Subject: NUCLEAR PROJECT NO. 2  
WNP-2 RESPONSE TO NUREG-0619

WNP-2 RESPONSE TO NUREG 0619  
"BWR FEEDWATER NOZZLE AND CONTROL  
ROD DRIVE RETURN LINE NOZZLE CRACKING"

SUPPLY SYSTEM RESPONSE  
TO FSAR QUESTION 121.008

A description of the WNP-2 feedwater nozzle and sparger is presented on Figures 121.8-1 and 121.8-2.

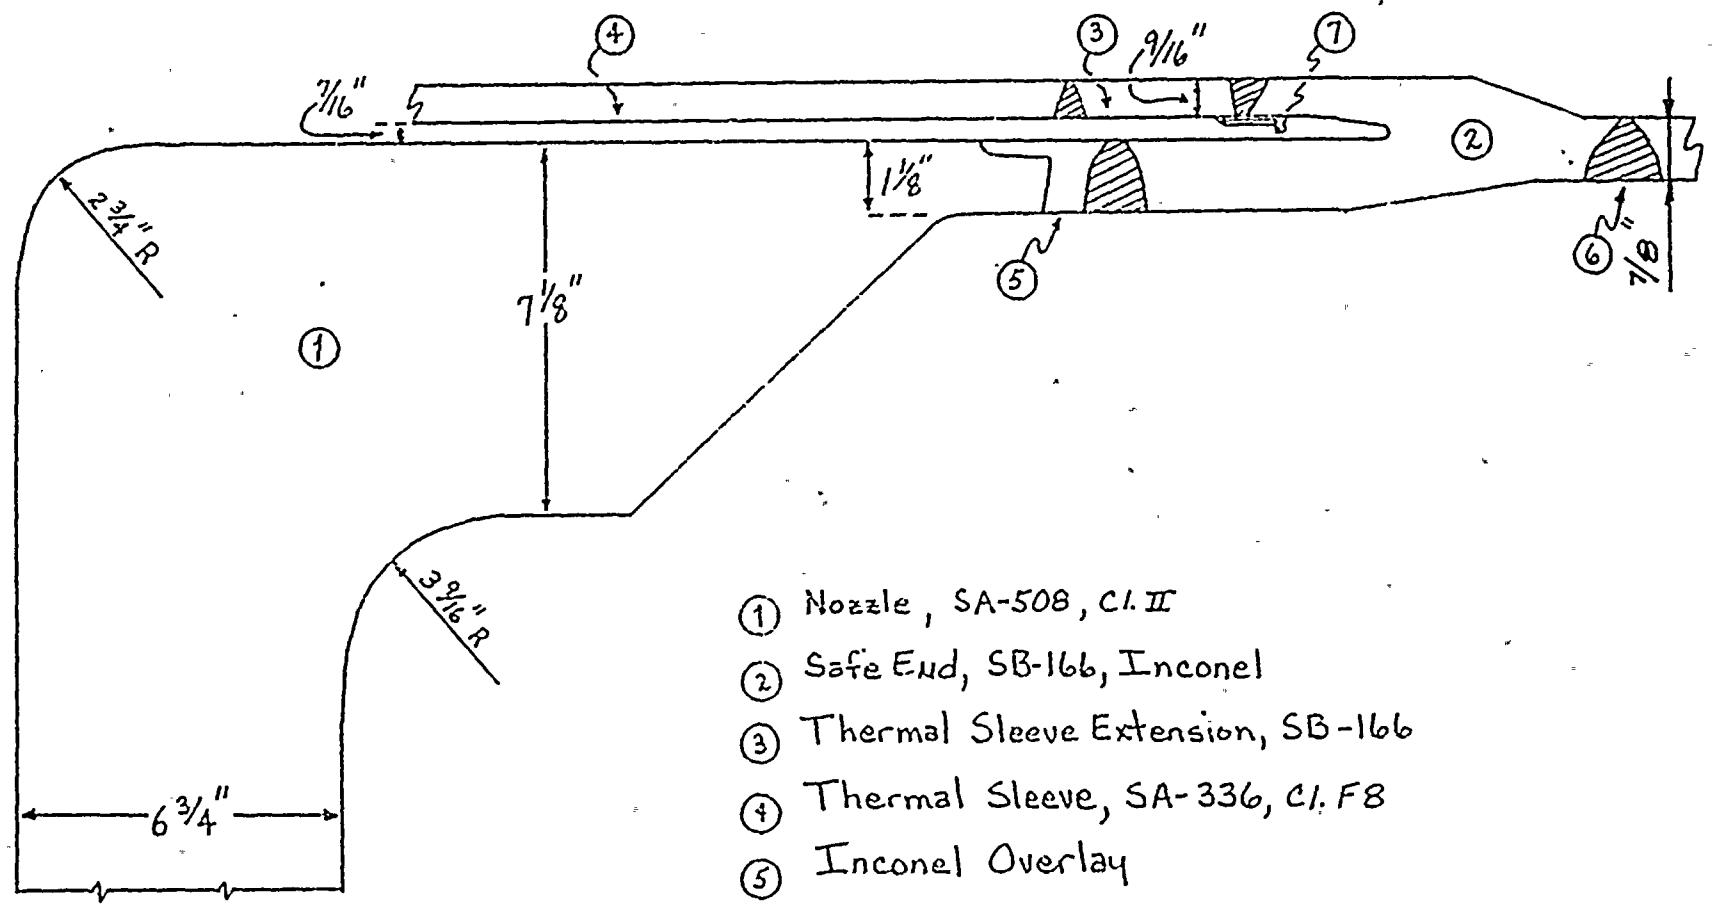
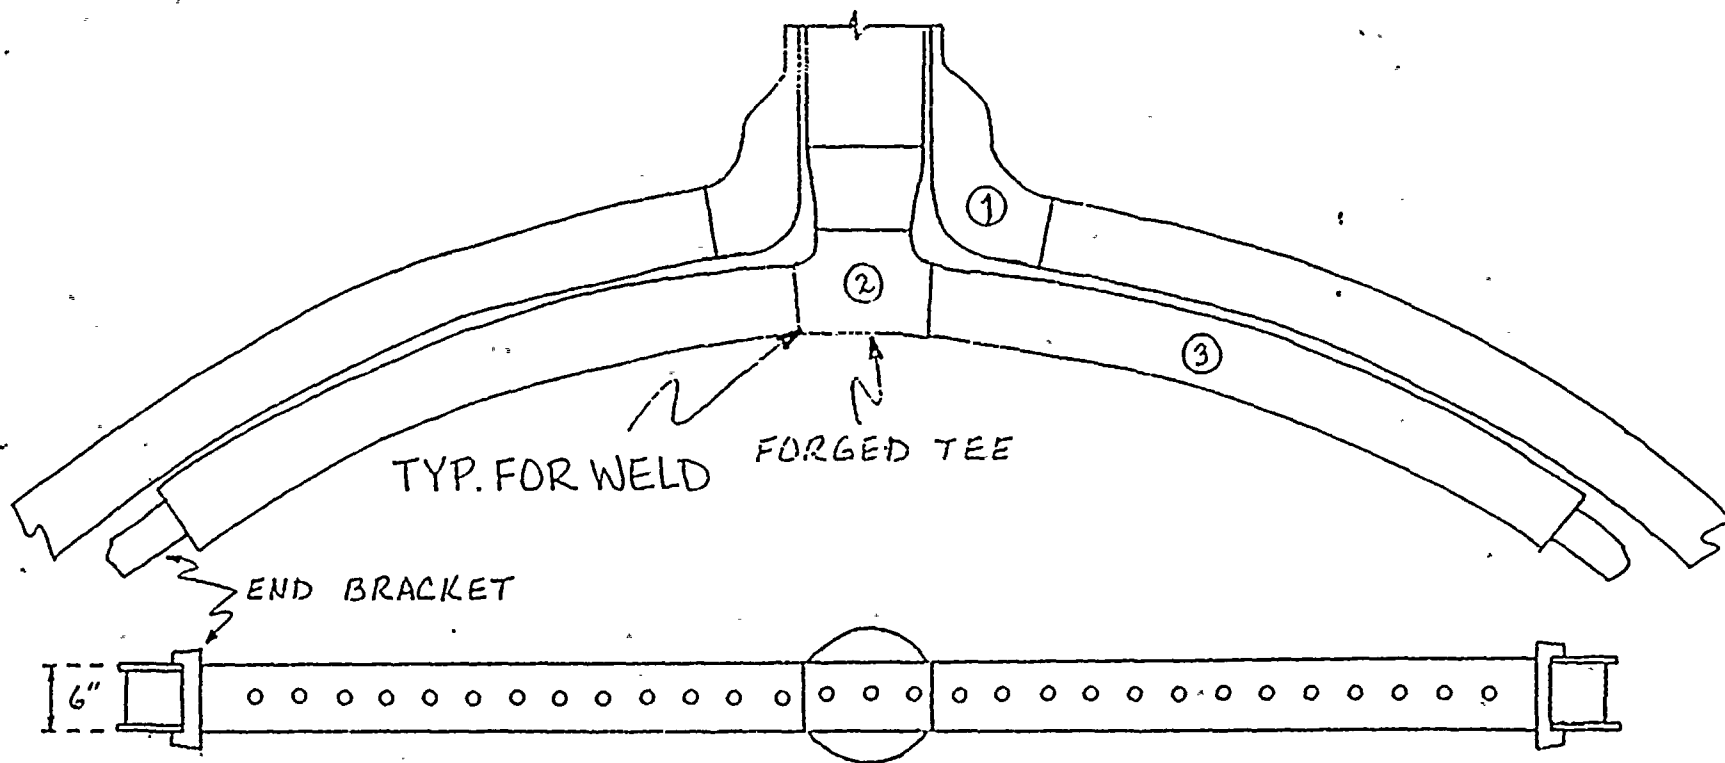
(In response to this item, refer to the responses to Items 121.15 and 121.18 on the Hatch-2 docket.) Additional information is required to demonstrate that: (1) the thermal sleeve/sparger design of the feedwater inlet nozzle has been evaluated with respect to potential nozzle cracking resulting from thermal cycling; and (2) a program of scheduled augmented inservice inspection has been developed.

Your response should contain: (1) a description of the nozzle and sparger design including the significant dimensions, the materials of construction and the weld locations; (2) a description of the analyses and test data, referencing appropriate data previously submitted to the NRC staff if it is applicable for the WNP-2 facility; (3) the detailed projected crack growth rates, stress levels and usage factors for both the nozzle and the sparger; (4) any plant modifications that are planned to reduce the temperature differential between the feedwater and the water in the reactor pressure vessel during low power operation; and (5) a description of any instrumentation that will be installed in the reactor pressure vessel to verify the conclusions of your design analysis.

- ① Nozzle, SA-508, C1. II
- ② Safe End, SB-166, Inconel
- ③ Thermal Sleeve Extension, SB-166
- ④ Thermal Sleeve, SA-336, C1. F8
- ⑤ Inconel Overlay
- ⑥ Weld Illustration
- ⑦ Back-up Ring, SB-168

- ① NOZZLE, SA-508, C1.II
- ② FORGED TEE, 304 S.S.
- ③ SPARGER HEADER, 304 S.S.
